Source: Ericsson
Title: DPCH synchronisation
Document for: Decision

5 Text proposal for 25.211 V2.2.1

6 Text proposal for 25.214 V1.1.1

Figure 2: Synchronization Establishment Flow of Dedicated Channels.

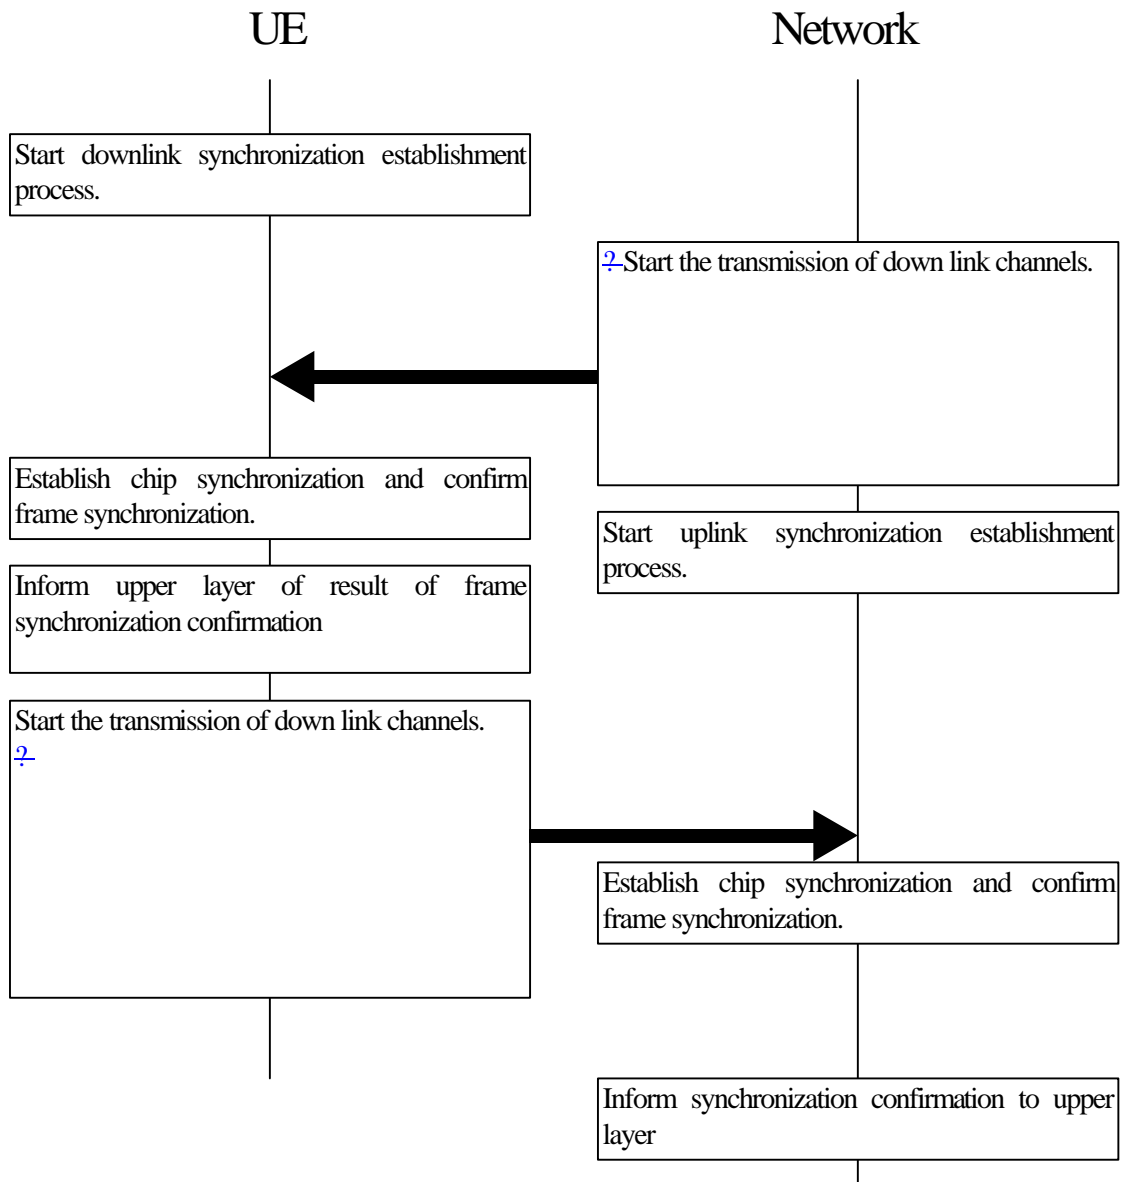
Below is a text proposal. Note that the figures have been modified to not be in contradiction to the text. In our view the figures can be removed from the specification, if they are not removed they need some polishing to look nice and be correct.

The ~~outline of~~ synchronization establishment procedures of the dedicated physical channel is described below. The ~~detailed~~ synchronization establishment process flow is shown in Figure 2.

- ~~UTRAN~~The network starts the transmission of downlink DPCCH/DPDCH channels. ~~The TPC commands transmitted by the network follows a predetermined pattern,~~ The DPDCH is transmitted only when there is data to be transmitted to the UE.

- b) The UE establishes downlink chip synchronization and frame synchronization based on the ~~Primary CCPCH/CPICH synchronization timing and timing offset information~~ the frame offset group, slot offset group notified from ~~UTRAN~~ the network. ~~The frame synchronization can~~ be confirmed using the Frame Synchronization Word. Successful frame synchronization is confirmed and reported to the higher layers ~~The success of the frame synchronization confirmation is determined when the successive- S_R successive frames have been confirmed to be frame synchronized~~ is confirmed. Otherwise, ~~the frame synchronization confirmation failure is determined. Then this synchronization status information is reported to the higher~~ upper layers.

- c) The UE starts the transmission of the uplink DPCCH/DPDCHs channels at ~~the a~~ frame timing ~~delayed by the slot offset~~ exactly T_0 chips after ~~from~~ the frame timing of the received downlink ~~channel~~ DPCCH/DPDCH. The DPDCH is transmitted only when there is data to be transmitted to the network. The UE immediately starts closed loop power control as described in sections 5.1.2 and 5.2.3, i.e. The transmission power of the uplink DPCCH/DPDCH ~~uplink channels follows the TPC commands transmitted by the network generated by UTRAN, and the UE performs SIR estimation to generate TPC commands transmitted to UTRAN, by the UE are based on downlink SIR measurements.~~

- d) ~~UTRAN~~ The network establishes uplink channel chip synchronization and frame synchronization, ~~based on the frame offset group and slot offset group.~~ Frame synchronization ~~can~~ be confirmed using the Frame Synchronization Word. Successful frame synchronization is confirmed and reported to the higher layers when S_R successive frames have been confirmed to be frame synchronized. Otherwise, frame synchronization failure is reported to the higher layers. ~~The success of the frame synchronization confirmation is determined when the successive S_R frame synchronization is confirmed. Otherwise, the frame synchronization confirmation failure is determined. Then this synchronisation status information is reported to the upper layer. The transmission power of the downlink channels follow the TPC commands transmitted by the UE.~~

Figure 3: Synchronization Establishment Flow upon Intra/Inter-cell Diversity soft Handover

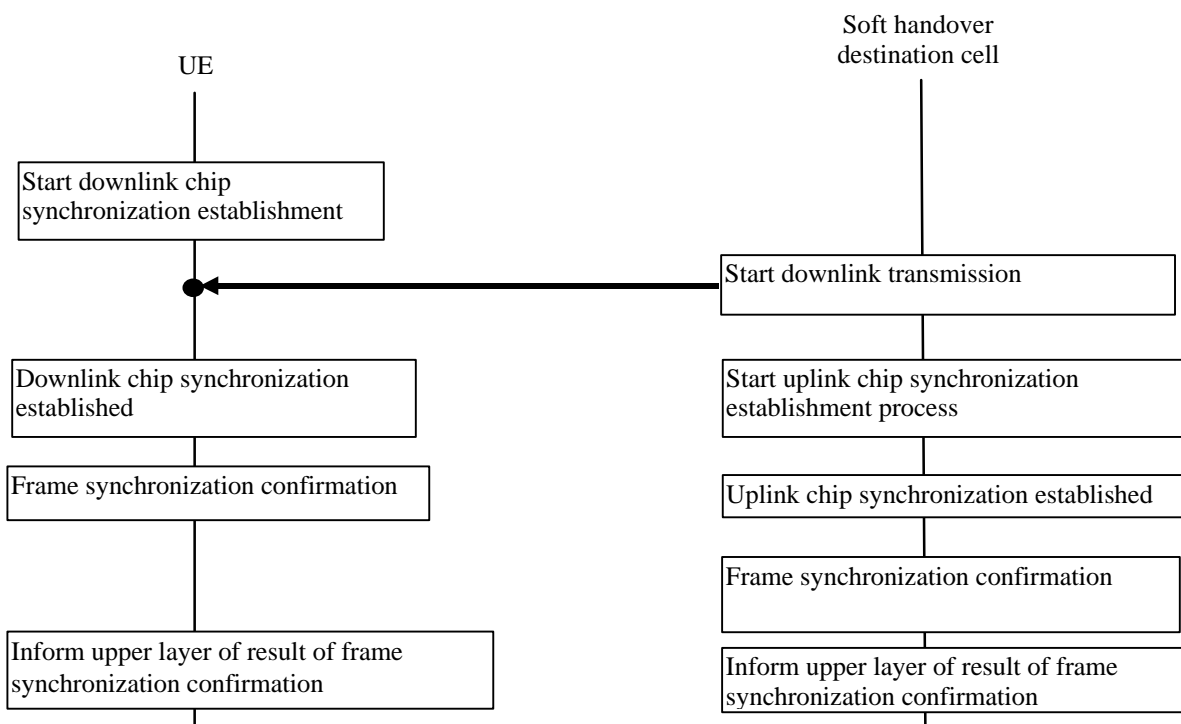
The synchronisation establishment flow upon intra/inter-cell ~~diversity-soft~~ handover is described in Figure 3.

- The UE starts the chip synchronisation establishment process of downlink channels from the handover destination. The uplink channels being transmitted shall continue transmission as before ~~without any operations performed.~~

- b) ~~The network UTRAN starts the transmission of the downlink dedicated physical channels DPCCH/DPDCH at a frame timing such that the frame timing received at the UE will be within $T_0 \pm 128$ chips prior to the frame timing of the uplink DPCCH/DPDCH at the UE. UTRAN then and starts the synchronization establishment process of the uplink dedicated physical channel DPCCH/DPDCH transmitted by the UE. -Frame synchronization could-can be confirmed using the Frame Synchronization Word. Successful frame synchronization is confirmed and reported to the higher layers when S_R successive frames have been confirmed to be frame synchronized. Otherwise, frame synchronization failure is reported to the higher layers. The success of the frame synchronization confirmation is determined when the successive S_R frame synchronization is confirmed. Otherwise, the frame synchronization confirmation failure is determined. Then this synchronization status information is reported to the upper layer.~~

- c) Based on the handover destination ~~Primary CCPCH/CPICH~~ reception timing, the UE establishes chip synchronisation of downlink channels from handover destination ~~node B~~ cell. Frame synchronization could-can be confirmed using the Frame Synchronization Word. Successful frame synchronization is confirmed and reported to the higher layers when S_R successive frames have been confirmed to be frame synchronized. Otherwise, frame synchronization failure is reported to the higher layers. The success of the frame synchronization confirmation is determined when the successive S_R frame synchronization is confirmed. Otherwise, the frame synchronization confirmation failure is determined. Then this synchronization status information is reported to the upper layer.
